BALTIMORE COUNTY PUBLIC SCHOOLS

ADDENDUM NUMBER _1_

BID NAME: NEW SCHOOL CONSTRUCTION LANSDOWNE ELEMENTARY
SCHOOL/DEMOLITION OF LANSDOWNE ELEMENTARY
SCHOOL__

BID NUMBER: **MBU-516-17**

SK- C -16

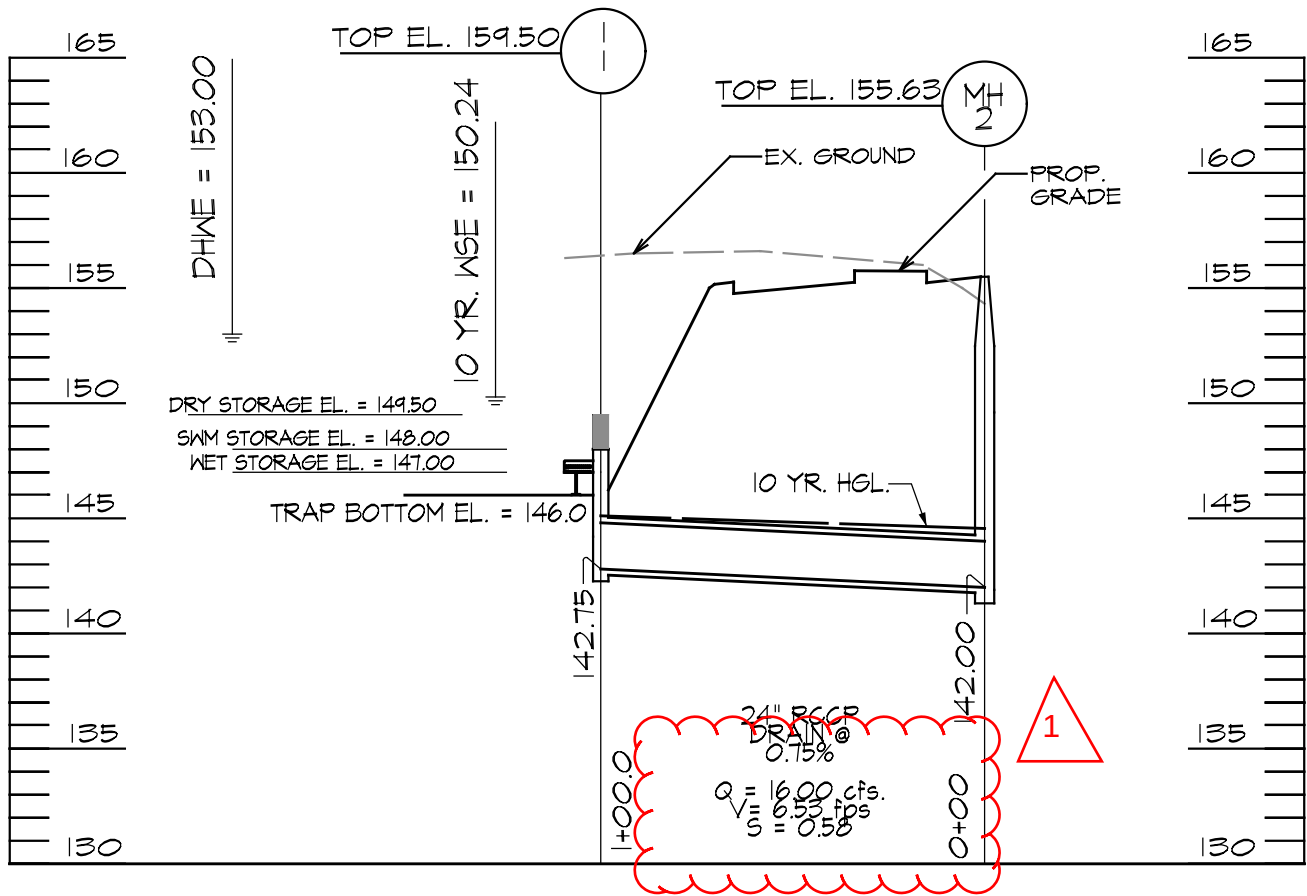
- 3.17. SHEET C-6.4, SEDIMENT AND EROSION CONTROL TRAP NO. 2 INSET PLAN
REMOVE: Parking count labels from Sediment Trap-2 Phase 1 Installation.
- REVISE:** Final Condition for SWM BIO #3 as indicated in attached sketch SK-C-16.

SK- C -16A

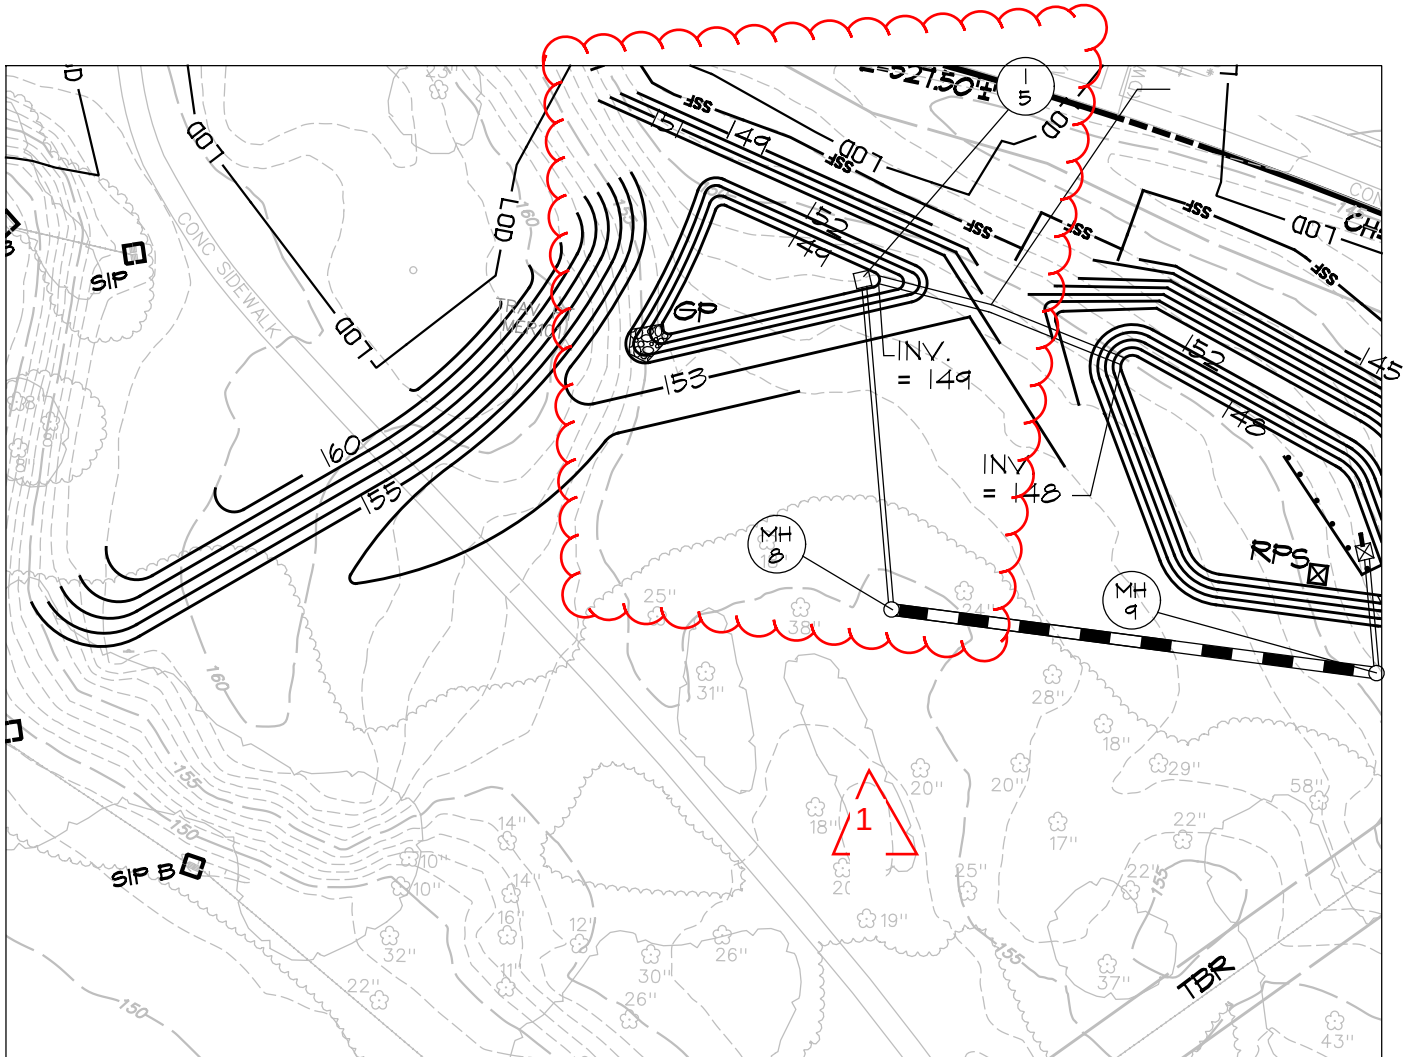
- REVISE:** Sediment Trap No. 2 Outfall Profile as indicated in attached sketch SK-C-16A.
- 3.18. SHEET C-6.5, SEDIMENT AND EROSION CONTROL TRAP NO. 3 INSET PLAN
REVISE: Sediment Trap-3 Phase 1 Installation as indicated in attached sketch SK-C-17.

SK- C -17A

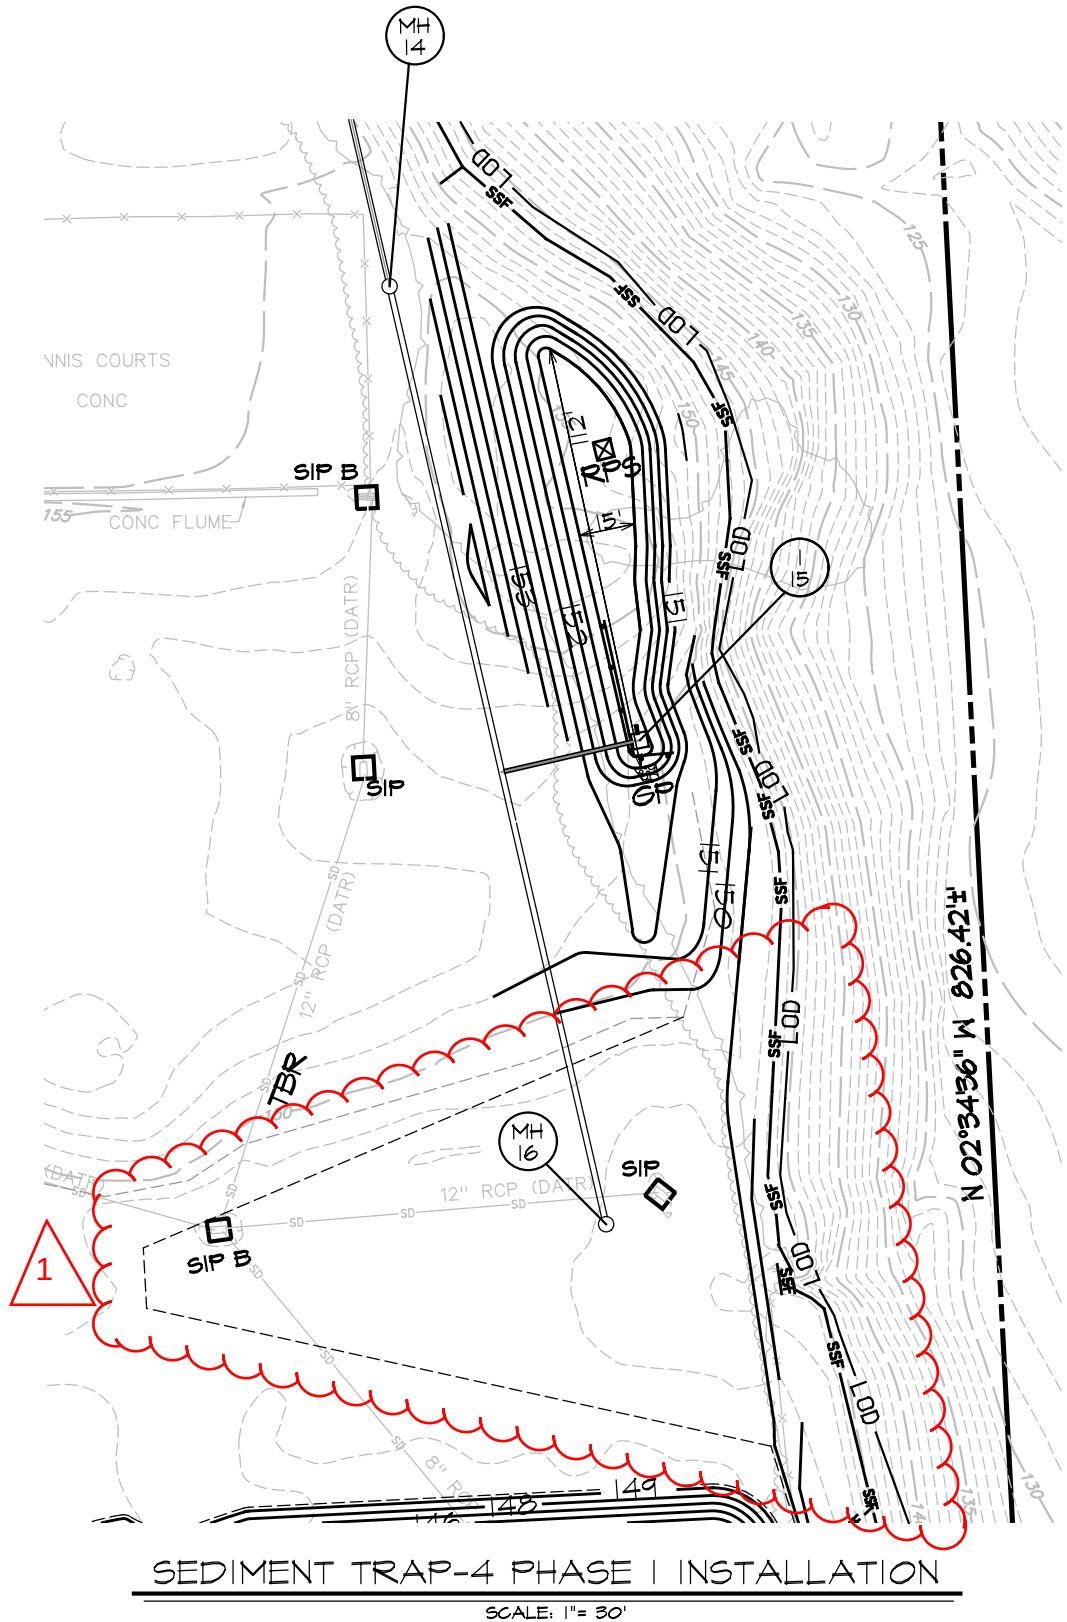
- REVISE:** Sediment Trap No. 3 Outfall Profile as indicated in attached sketch SK-C-17A.

SK- C -18

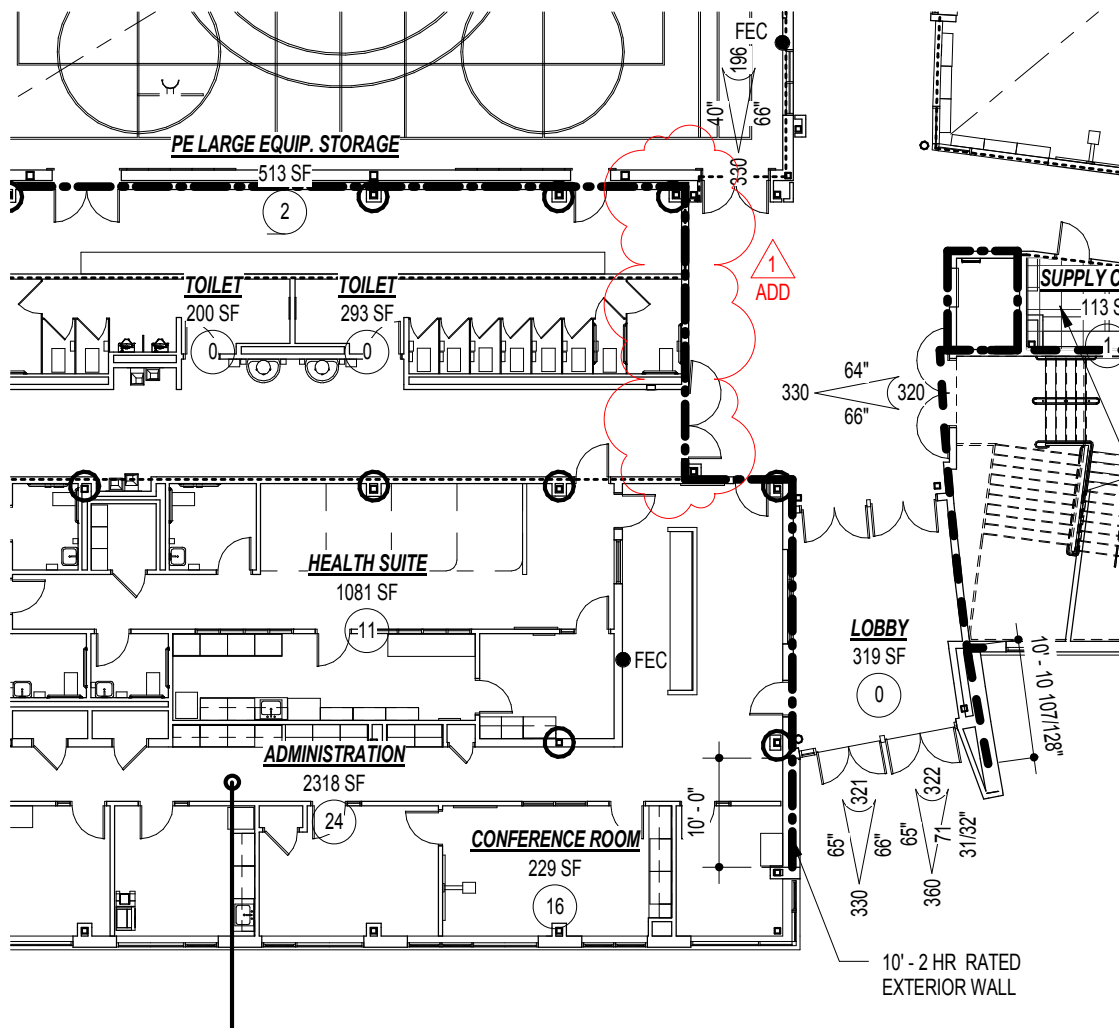
- 3.19. SHEET C-6.6, SEDIMENT AND EROSION CONTROL TRAP NO. 4 INSET PLAN
REVISE: Sediment Trap-4 Phase 1 Installation as indicated in attached sketch SK-C-18.
- REVISE:** Sediment Trap No. 4 Outfall Profile as indicated in attached sketch SK-C-18A.
- 3.20. SHEET C-7.1, FINAL STORMWATER MANAGEMENT PLAN
DELETE: Shading in proposed 75' softball diamond(southeast), as the field is not impervious.
- 3.21. SHEET C-7.3, FINAL STORMWATER MANAGEMENT DETAILS
REVISE: Structure label on Bioretention Facility #1 profile from M-19 to M-9.
- REVISE:** Structure label on Bioretention Facility #2 profile from I-2 to I-15.
- 3.22. SHEET C-7.4, FINAL STORMWATER MANAGEMENT DETAILS
REVISE: Structure labels on Plan view from ES-2 to ES-3.

SK-A-1.1

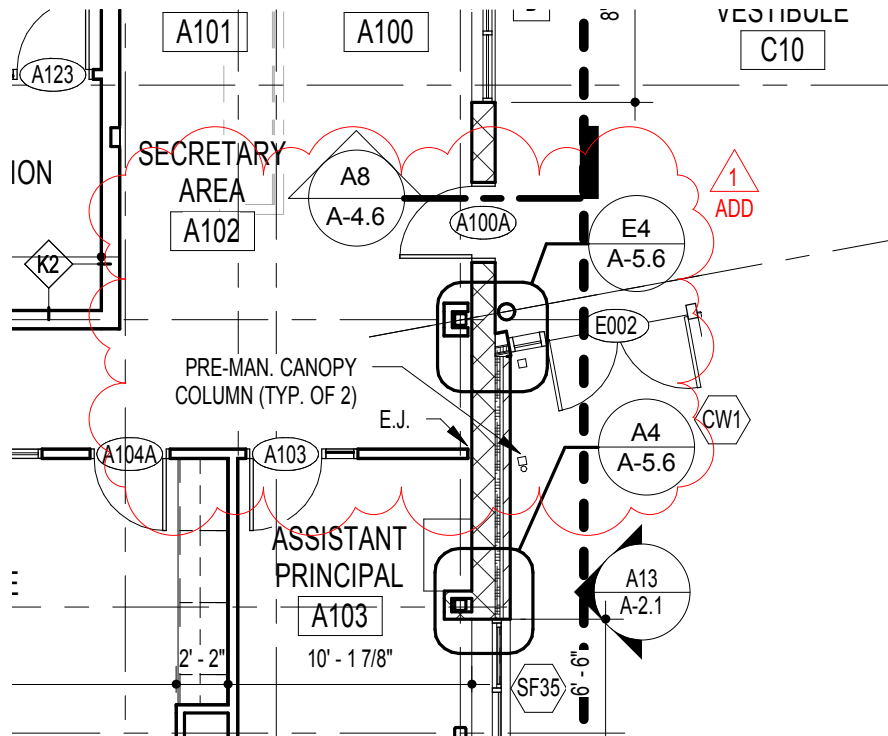
- 4.1. SHEET A-0.1, CODE STUDY
REVISE Location of firewall at PE Large Equip. Storage per attached sketch
SK-A-1.1.
- 4.2. SHEET A-1.1A, PARTIAL FIRST FLOOR PLAN – AREA A
ADD Pre-manufactured canopy columns per attached sketch SK-A-1.2.
- 4.3. SHEET A-3.2, DOOR SCHEDULE
ADD Note 11 to doors C158A and C158B.
- 4.4. SHEET A-4.5, WALL SECTIONS
REVISE Entrance canopy at Doors E001 and E002 in section A5, per attached SK-A-1.3.
- REVISE** Sill detail at Corridor C20 in section A8 to "J2/A-3.3 SIM".
- 4.5. SHEET A-4.6, WALL SECTIONS
ADD Parapet reference J10/A-1.4 to section A4.
- REVISE** Bulkhead and acoustic panels in section A4 per attached sketch SK-A-1.4

SK-A-1.5

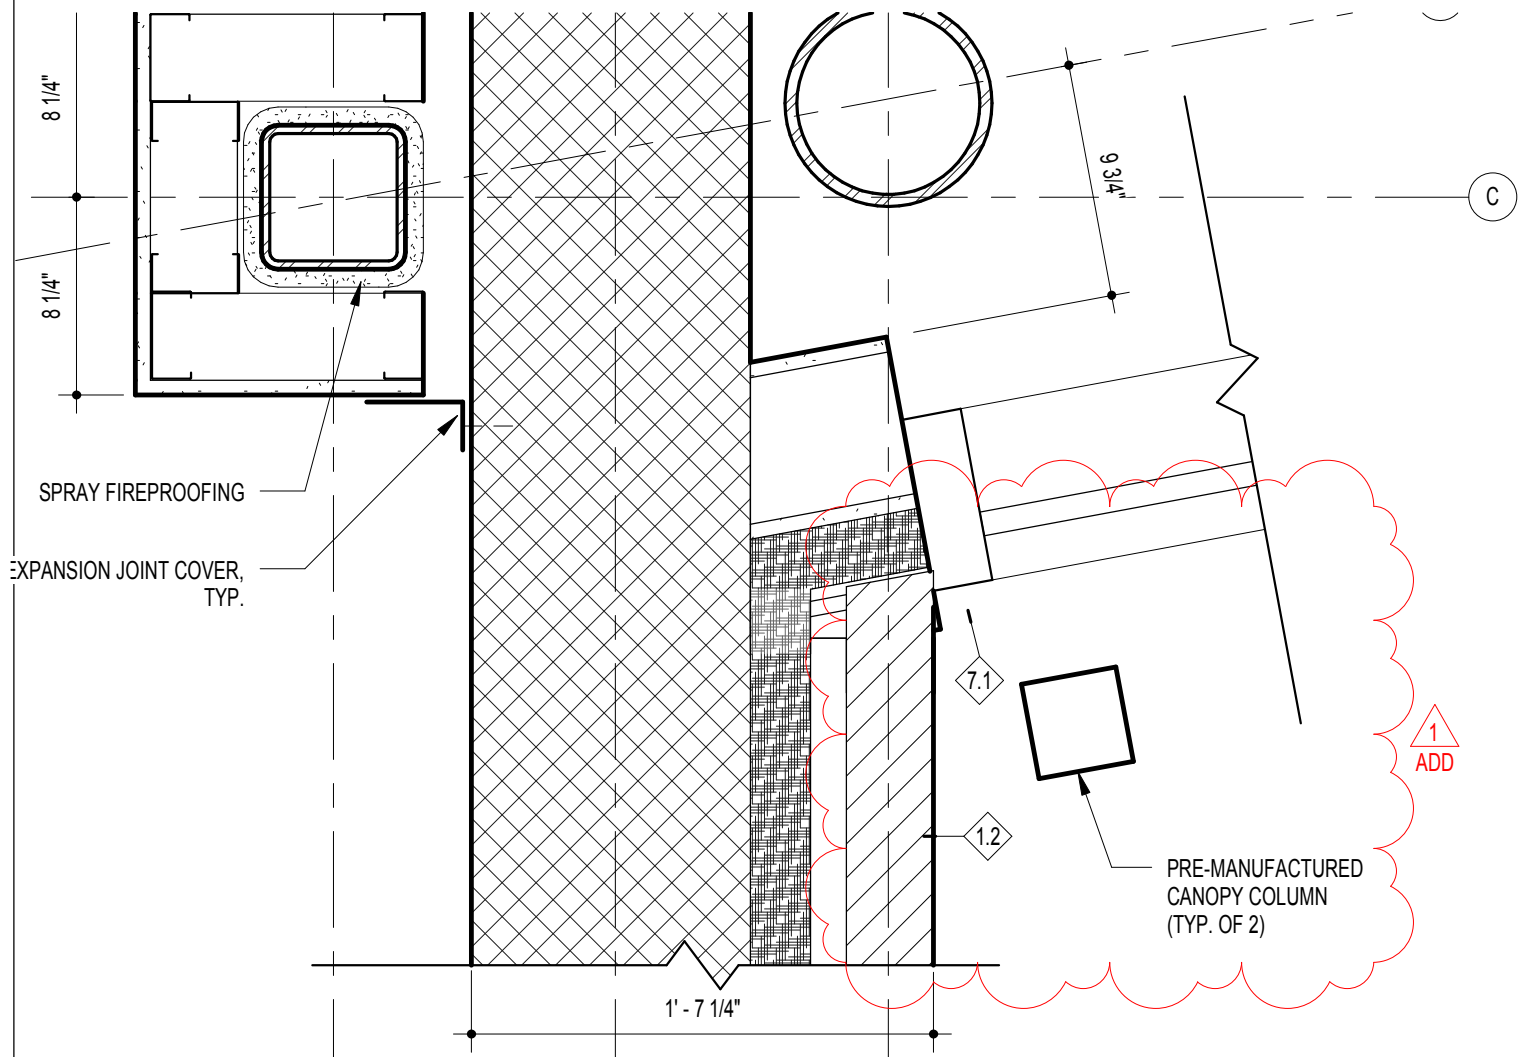
- 4.6. SHEET A-5.3, STAIR PLANS AND SECTIONS
REVISE Notes at top of highest riser and lowest riser in detail F16 to "Extent of terrazzo flooring."
- 4.7. SHEET A-5.5, TYPICAL DETAILS
REVISE Head of louver detail H17/A-5.5 per attached sketch SK-A-1.5.
- 4.8. SHEET A-5.6, PLAN DETAILS
ADD Pre-manufactured canopy columns, per attached sketch SK-A-1.6.
